Lower Thames Crossing DCO

Gravesham Borough Council

Appendix 1a

Gravesham Borough Council's responses to agenda items for ISH 11 on Environmental Matters – with additional post-hearing notes

Figure 1.0 Map received from LTC Team - March 2020

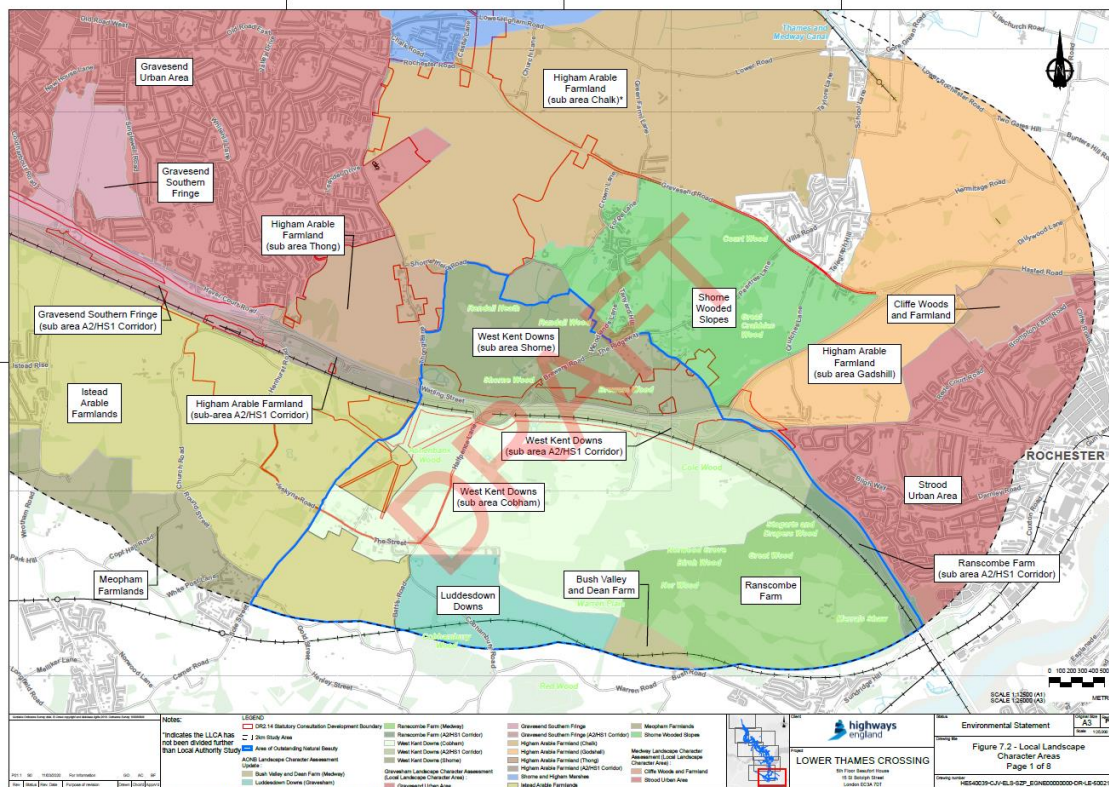
By way of background the LTC Team has previously proposed changes to the Local Character Areas south of the river in Gravesham Borough. The map in Figure 1.0 shows the proposed changes, submitted to Gravesham Borough Council in 2020. The map proposes the sub-dividing of the West Kent Downs LCA into a number of smaller sub-areas, and a new LCA created. The map clearly shows Cobham sub-area LLCA sub-divided into Cobham, and A2/HS1 Corridor, and part of the existing Cobham LLCA was proposed to be a new LCA called Ranscombe Farm, with a new sub-area of Ranscombe Farm (sub-area A2/HS1 Corridor). Gravesham BC rejected this proposal (see also GBC response)

The Borough Council has reviewed the information the Lower Thames Crossing team sent and also consulted with our landscape consultant, the Kent Downs AoNB Unit and Natural England.

The guidance for Landscape and Visual Impact Assessment sets out that it is appropriate to consider when doing analysis whether any changes have occurred that might provide a justification for departing from the existing zones. There have been no changes of any significance to alter the landscape zones since the technical work was carried out in Gravesham.

In the Kent Downs AoNB the landscaping (existing and provided as part of schemes) has matured, and whether on A2 eastbound, A2 westbound, or HS1 the corridor reads as part of a wider landscape.

Due to the carriageway separation and the landscaping between the A2 and HS1 the effect of the transport infrastructure is significantly reduced. The presence of motorways and railways in an AoNB is a matter of fact and not inherently a reason for a landscape zone of their own.

In this area in particular there is an important historical component to be taken into account in that it was all part of the wider Darnley Estate, which was managed as a unit. Whilst the land ownership has fragmented over the years the area has none the less has retained its overall character.

The suggestion that your proposed scheme would have only medium impact on the corridor itself is not accepted as it is clear that Lower Thames Crossing scheme, especially as consulted upon in the Supplementary Consultation, must have a high impact on this area as it effectively destroys the current A2 and HS1 landscaping and creates a very urban corridor.

The proposed changes are not therefore acceptable and the scheme should be assessed against existing landscape zones.
